Primary Engineering, Inc.
2828 Lake Ave.
Fort Wayne, Indiana 46805
260-424-0444 ph
www.primary-eng.com

Addendum: 1
Date: 3/29/2024
Project: PFW Walb Student Union
Passenger Elevator Repair - 2024
Comm #: 23517

GROUND FLOOR ELECTRICAL DEMOLITION PLAN
1
1/8" = 1'-0"

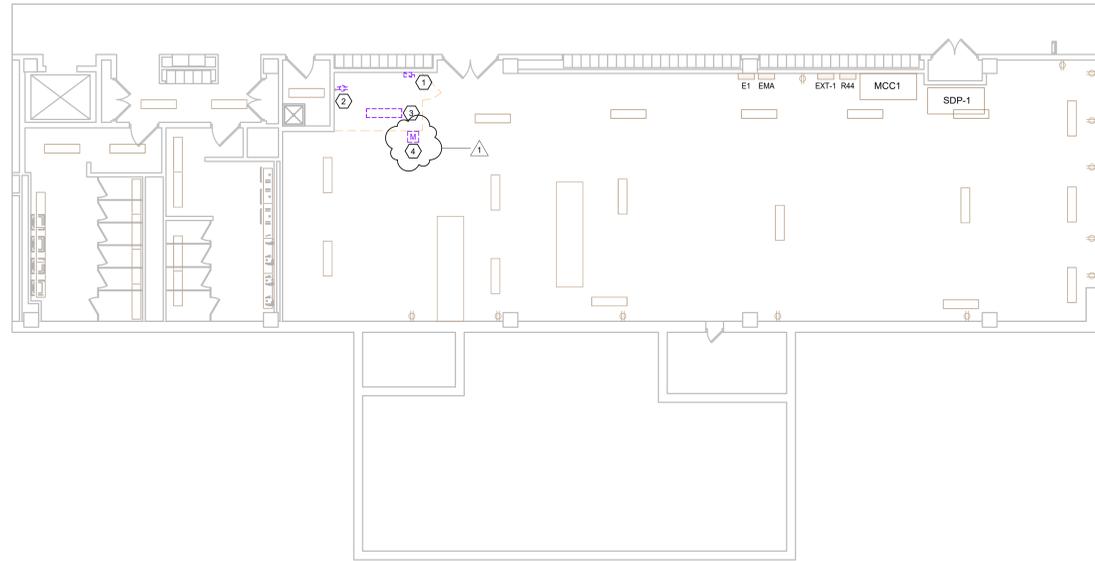
Item #2: Drawing Sheet E201.

- A. Removing existing meter mounted on existing fence. Refer to supplemental drawing E201 for additional information.

1. DISCONNECT AND REMOVE EXISTING ELEVATOR DISCONNECT. EXISTING WIRING TO BE REMOVED. PREPARE EXISTING LOCATION FOR NEW ELEVATOR DISCONNECT.
2. DISCONNECT AND REMOVE EXISTING SURFACE MOUNTED RECEPTACLE. EXISTING WIRING TO BE REMOVED. PREPARE CONDUIT AND EXISTING LOCATION FOR FUTURE DEDICATED GFI RECEPTACLE.
3. DISCONNECT AND REMOVE EXISTING LIGHT FIXTURE AND CIRCUIT BREAKER SERVING FIXTURE. EXISTING WIRING TO REMAIN. PREPARE WIRING AND CONDUIT TO BE EXTENDED AS NECESSARY FOR NEW FIXTURE AND NEW 120V 20A/1P LOCKABLE CIRCUIT BREAKER.
4. DISCONNECT AND REMOVE EXISTING METER. EXISTING CONDUCTORS AND CONDUIT TO BE REMOVED BACK TO SOURCE.
